AERONAUTICAL CHARTING FORUM
Instrument Procedures Group
Meeting 14-02 – October 28, 2014

RECOMMENDATION DOCUMENT

FAA Control # 14-02-318

Subject: Charting LNAV Engagement Altitudes

DANLS TWO DEPARTURE (RNAV)

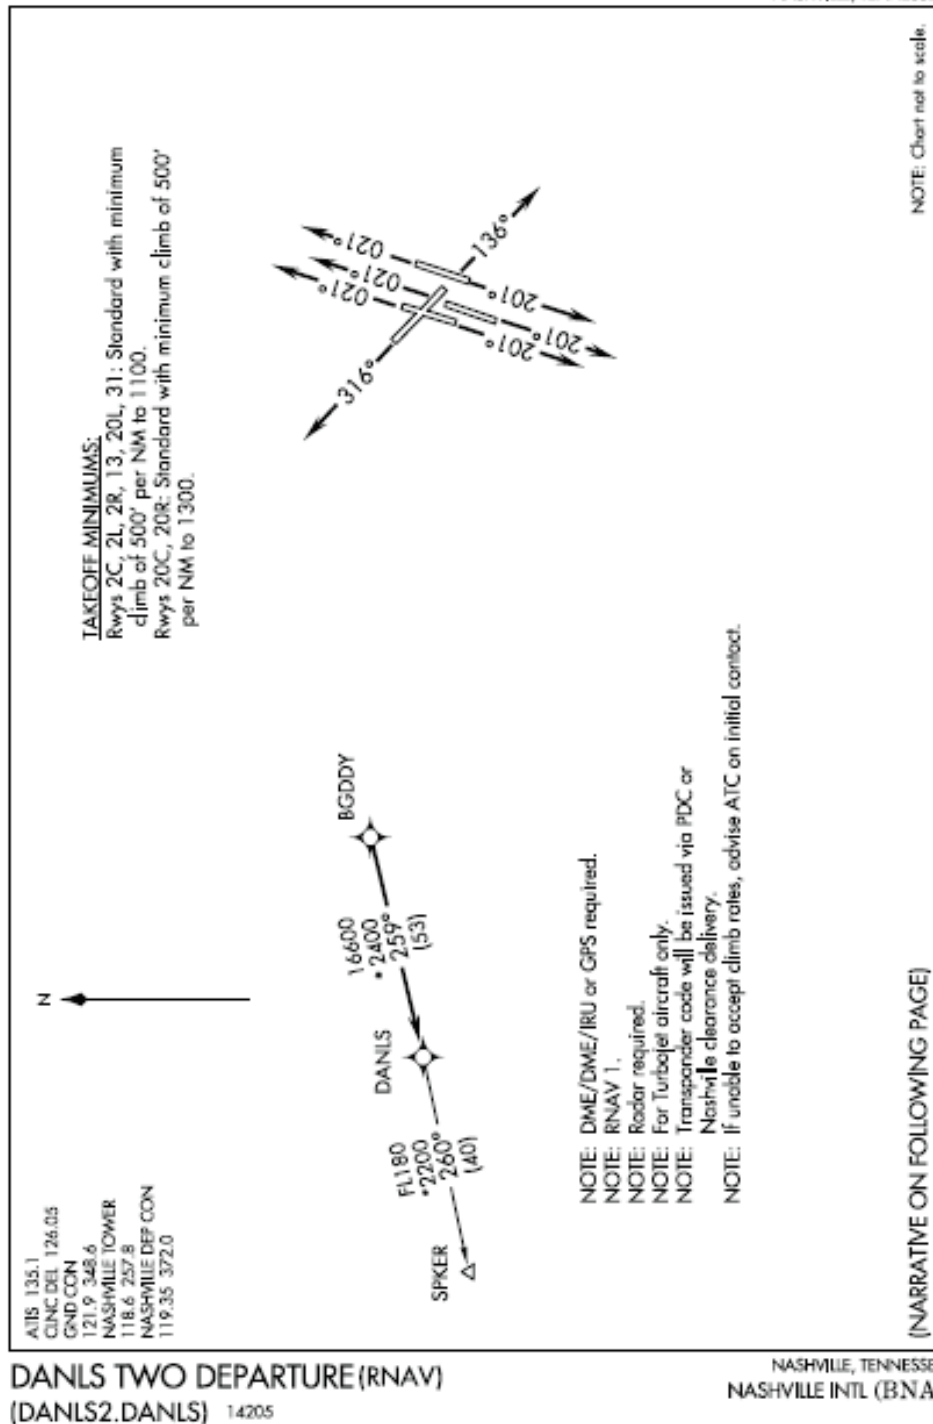
Examples will be provided as it is the best way to see the breadth of the problem, but in general some SIDs have them and some do not. In most cases they only contribute to chart clutter and no useful purpose (see attached charts). Additionally, they may be charted as “usable altitudes” such as “1800” or may show up as “less usable altitudes” such as “1861”. It is possible that they are charted as “at”, “at or below”, or “at or above”, but really serve no purpose other than to anchor the RNAV leg type. Also, Jepp has added a “climb to” on the planview (consistent with AeroNav products text) that may be confusing pilots that think it is an altitude restriction.

These inconsistencies have been showing up as ASRS/ASAP reports, complaints, and pilot deviations. Of the most recent errors, crews were leveling at the LNAV engagement altitude on new KOKC SIDs that are 500 ft. above the ground (a contributing factor could be that “Climb Via SID” clearance was issued instead of “Climb and Maintain”- the SID has no published constraints other than the LNAV engagement altitude.). Additionally, it has been shown that pilot knowledge of “LNAV engagement altitudes” is very low. In many cases, the designation is just ignored, producing an industry wide illusion of understanding. In fact, there appears to be very little published on the topic and the name alone is a misconception since a true “LNAV engagement altitude” varies by aircraft type and is designated by the manufacturer and certified by flight standards processes. There are also discussions occurring as to whether or not these LNAV engagement altitudes are “altitude constraints” at all and how they should be treated by ATC.

1. FAA clearly define criteria requirements for the LNAV engagement altitude (or its appropriate designation).
2. Determine the need for charting and standards necessary that will prevent confusing interpretations.
3. The AIM, PCG and Instrument Procedures Handbook should be updated to incorporate the appropriate guidance necessary related to the LNAV engagement altitude.
